**To:** The Design Advisory Board  
**From:** Mary O'Neil, AICP, Senior Planner  
**RE:** ZP 14-0238SP; 237 North Winooski Avenue  
**Date:** September 10, 2013

**File:** ZP 14-0238SP

**Location:** 237 North Winooski Avenue

**Request:** Demolish former Dairy Queen / existing "Q-Tee-s" restaurant, redevelop site with a single building of 28 residential units and 1,500 sf commercial space. Parking is proposed to be located under the building in an open garage.

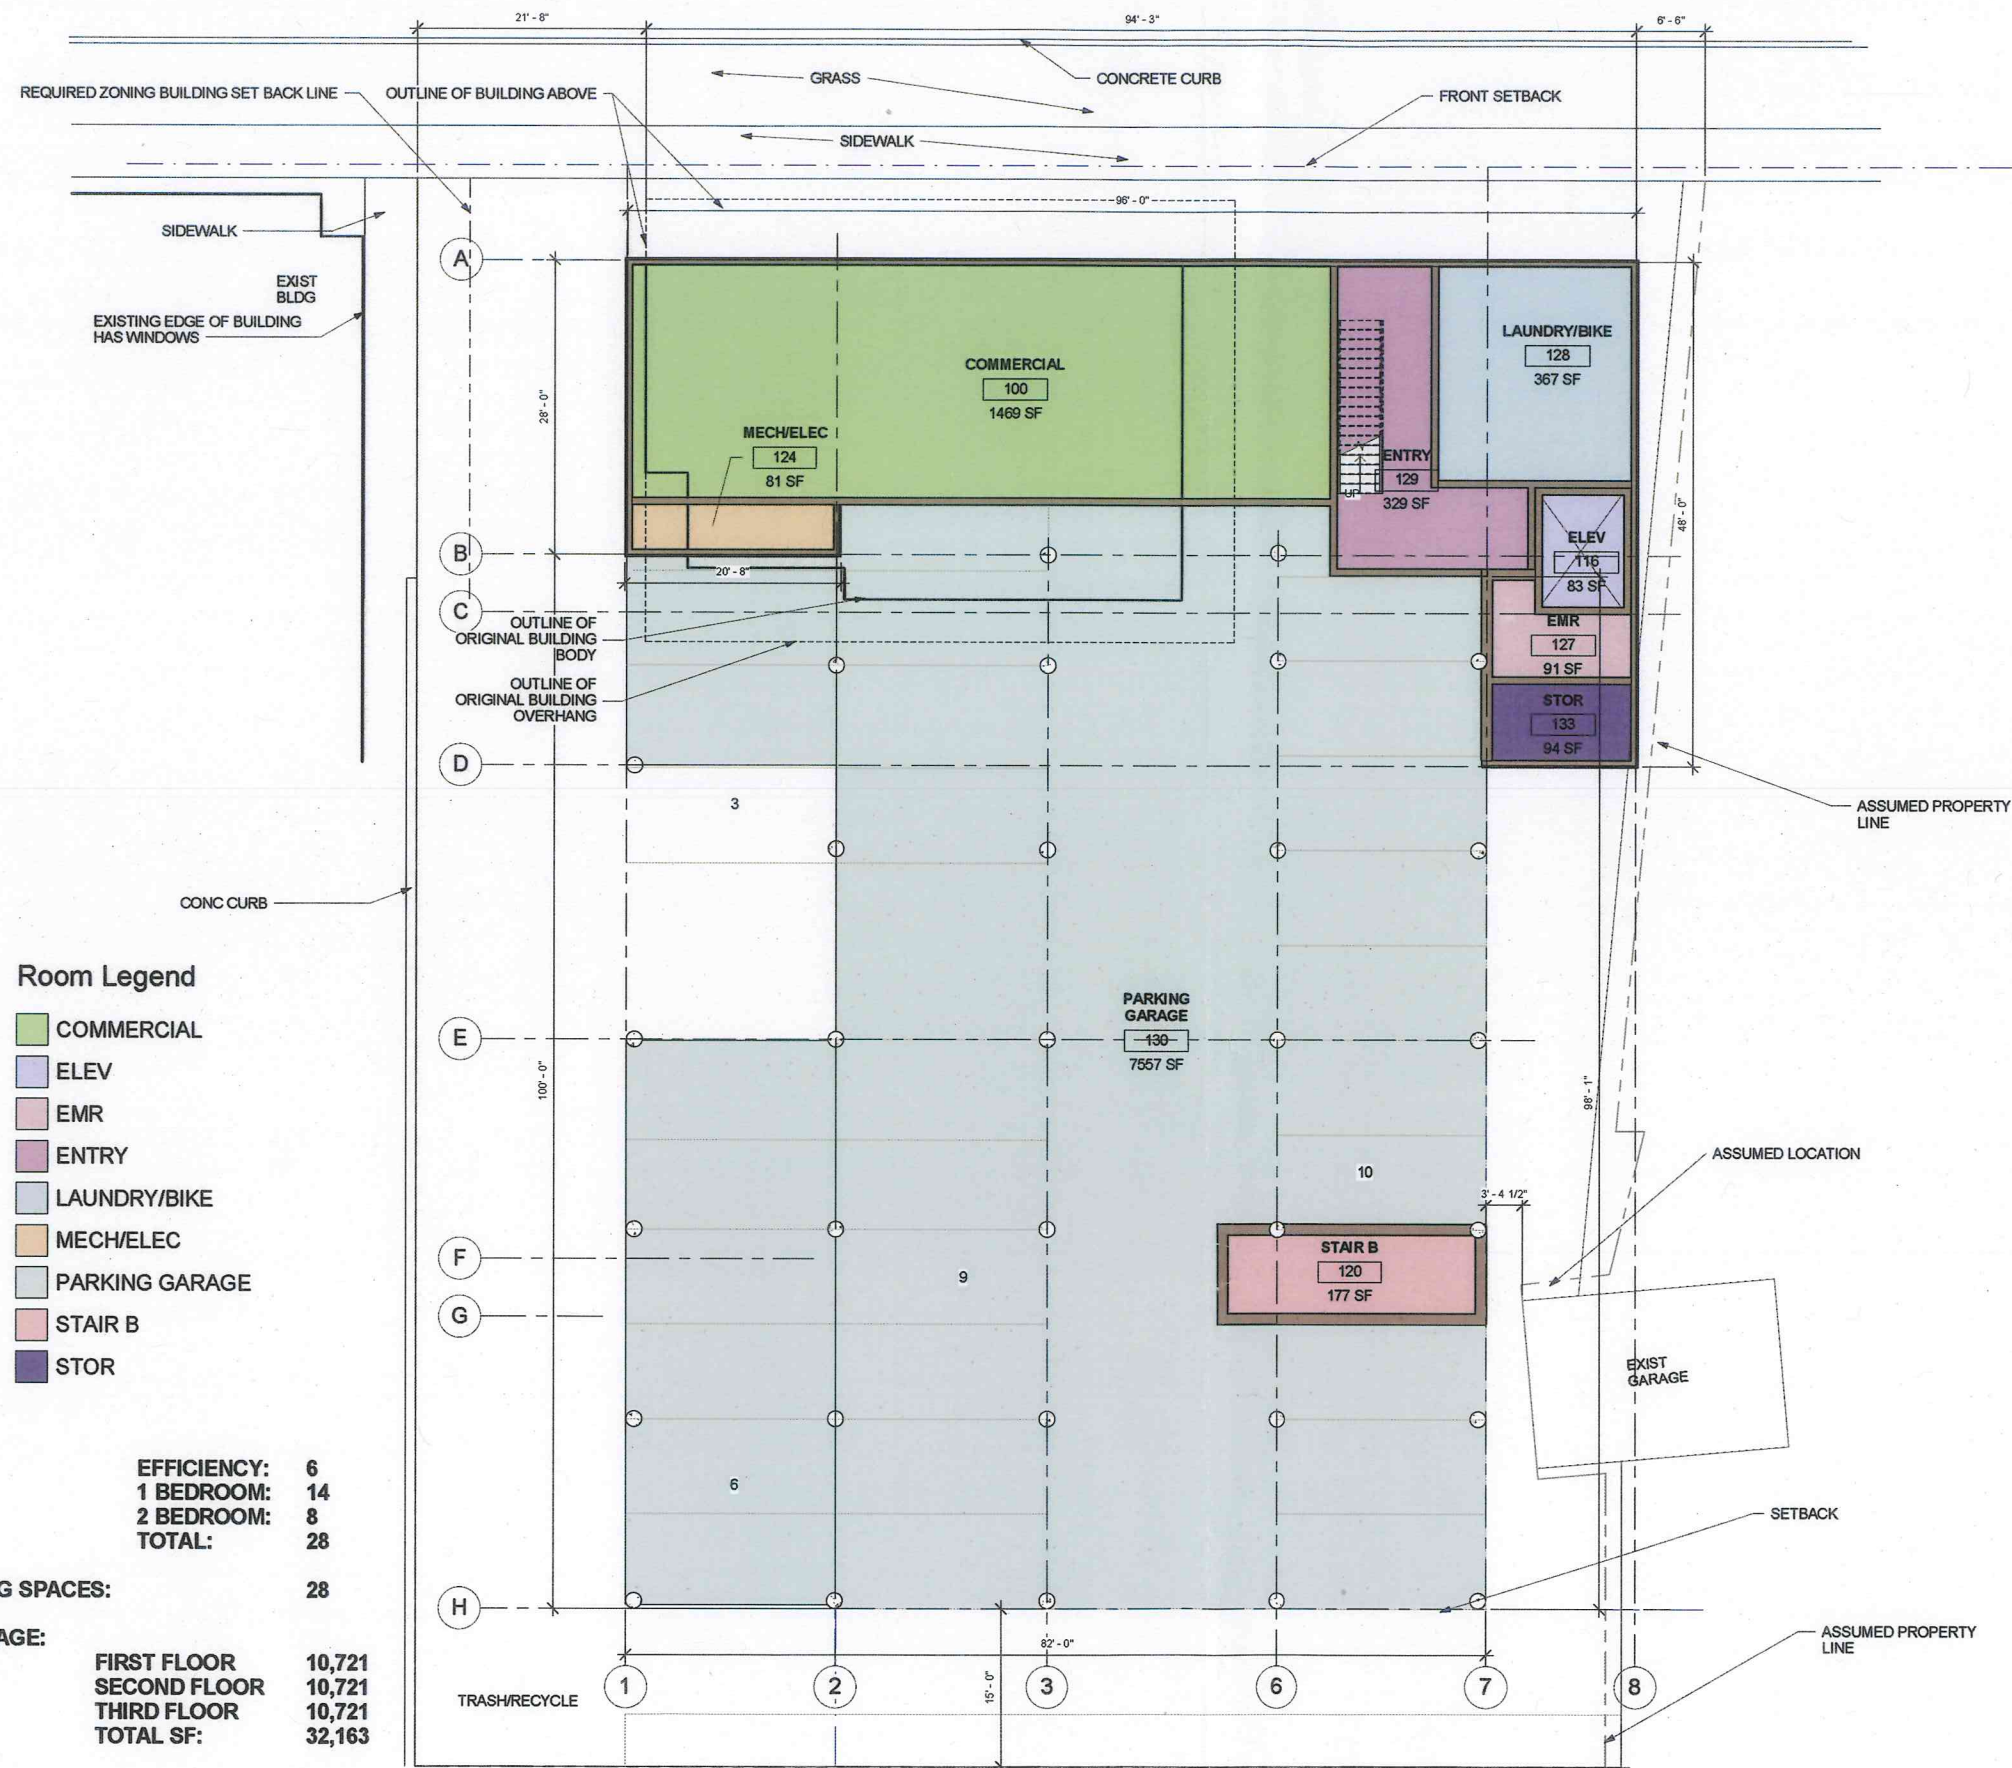
The site plan illustrates the building front aligned with the curb and “completing” the street front between the Multi-Gen center (241 North Winooski Avenue) and the corner residential building at 221 North Winooski Avenue.

Footnote 4 in Table 4.4.2-1 requires a 12’ setback from the curb. The scale is not accurate on the submitted site plan due to image reduction; therefore it is impossible to discern the actual plan setback.

Without elevations, building entrances cannot be confirmed; however an entry location is identified on floor plans, as well as commercial space which would presumably have an entrance door facing the street. This will need to be confirmed with developed elevation drawings.

No accessory buildings are illustrated on the site plan – however an area marked “trash/recycling” is noted. No details have been provided. Any trash enclosure or screening (which will likely be required) will be subject to Design Review standards of this ordinance.

The parking portion of the structure is set behind the commercial use, as understood from submitted floor plans. Little else is explained – no parking space size, no circulation pattern, no

access description, no definition between standard parking spaces and compact spaces, no space numbers. Much more information will be required.

There is an area marked "laundry/bike" which is assumed to be long term bicycle storage. Significant bicycle parking will be required with this development, and needs to be further developed prior to advanced review.
